APPLICATION NO.	FILING DATE	FIRST NAMED INVENTOR	ATTORNEY DOCKET NO.	CONFIRMATION NO.
09/919,324	07/31/2001	John C. Alderman	US010355	3730
24737	7590	12/17/2003		
PHILIPS INTELLECTUAL PROPERTY & STANDARDS P.O. BOX 3001 BRIARCLIFF MANOR, NY 10510			EXAMINER MACCHIAROLO, PETER J	
			ART UNIT 2875	PAPER NUMBER

Office Action Summary	Application No.	Applicant(s)	
	09/919,324	ALDERMAN ET AL.	
	Examiner	Art Unit	
	Peter J Macchiarolo	2875

DETAILED ACTION

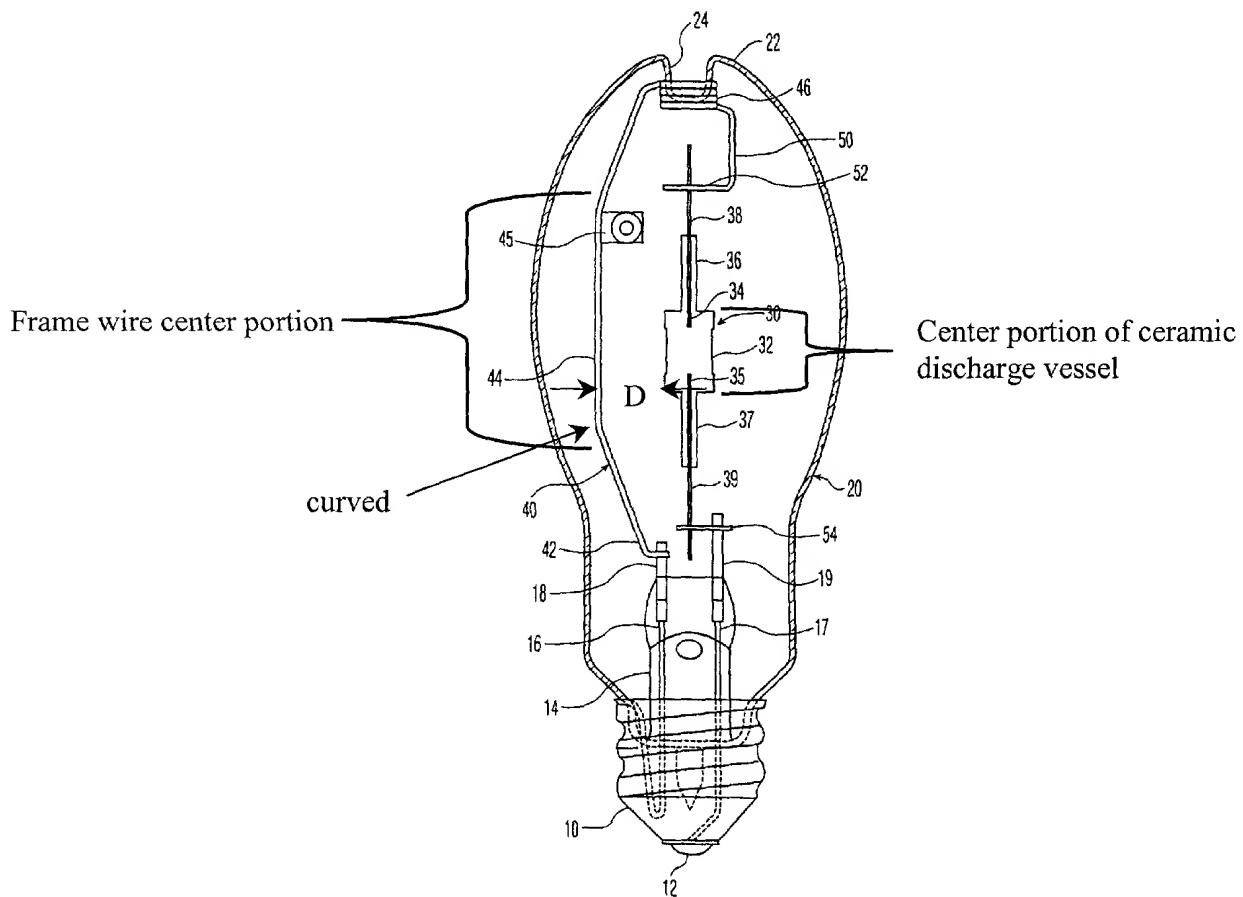
3. In regards to claims 1 and 17, Shippee discloses in figures 2 and 3, an outer bulb (20) enclosing a ceramic discharge vessel (30) enclosing a discharge space, wherein the cylindrical ceramic discharge vessel includes an ionizable material which is a metal halide, a first (16) and a second (17) discharge electrode feedthrough means, and a first (18) and a second (19) current conductor connected to the first and second discharge electrode feedthrough means respectively, the discharge lamp having a single substantially curved frame wire (40) supporting the ceramic discharge vessel and connected to one of said current conductors (18), and extending between the ceramic discharge vessel and the glass bulb. Shippee further discloses that the curved frame

wire is curved away from the ceramic discharge vessel and toward the glass bulb at least in a center portion adjacent a center portion of the ceramic discharge vessel whereby the center portion of the curved wire frame and the center portion of the ceramic discharge vessel are separated by a distance D (see below). The Examiner notes that the claim limitation:

11. However, the only limitation that Applicant uses to further define "a center portion" is that it is adjacent to a center portion of the ceramic discharge vessel. Figure 2 of Shippee has been reproduced above to clearly show that the center portion is indeed curved adjacent to a center portion of the ceramic discharge vessel.
